Environmental Impact Statement (EIS) assessment report under the *Environmental Protection Act 1994*

Drake Coal Project proposed by Drake Coal Pty Ltd
(A wholly owned subsidiary of QCoal Pty Ltd)

Prepared by: Statewide Environmental Assessments, Department of Environment and Heritage Protection

September 2013

Figure 2 - Cross-section of levee buttress proposal around West Pit 1 final void (Source: Drake Coal Project - EM Plan)

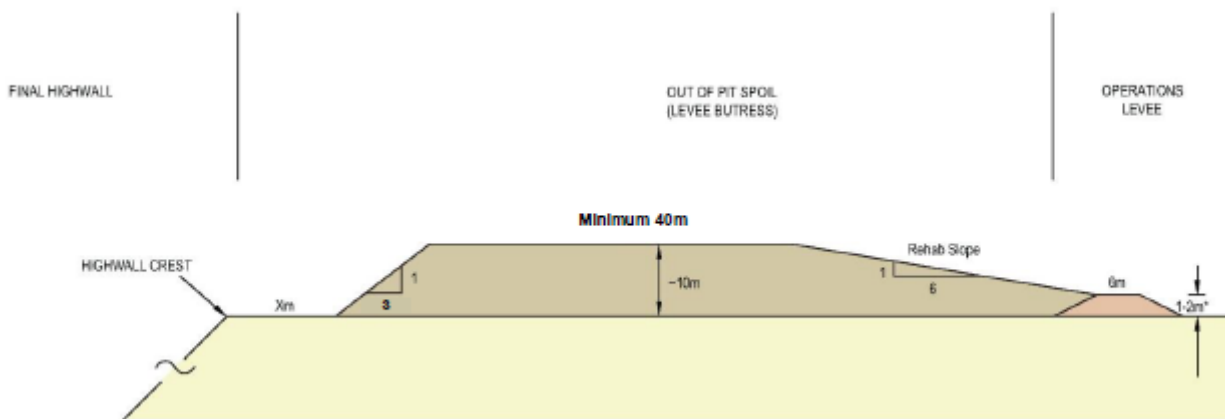
EHP, the Mackay Conservation Group and one public submission commented on the EIS that the 1-in-1000-year levees proposed to protect West Pit 1 and East Pit 4 during operations would be insufficient to protect these voids from overtopping in the longer term after mining had been completed. EHP requested the proponent to revise the mine closure plan. The proponent provided further information in the SEIS and in additional correspondence received on 8 July 2013. As identified in section 2 of this report, the proponent has committed to completely backfilling the East Pit 4 void, removing the need for a levee after mining has been completed. The proponent also committed to reducing the final footprint of the West Pit 1 final void and ensuring that the void would be protected from floodwaters above the probable maximum flood (PMF) level. The commitments for the rehabilitation of West Pit 1 include:

- completely backfilling the northern void
- reducing the volume of the southern void
- construct a 10m high spoil buttress behind the operational levee to provide flood protection for the void above the PMF level (see Figure 2).

EHP considered the proposal and determined that it provided adequate flood protection for the West Pit 1 final void. A condition about the decommissioning of final voids with flood protection above the PMF level would be included in the project EA (Appendix 2).
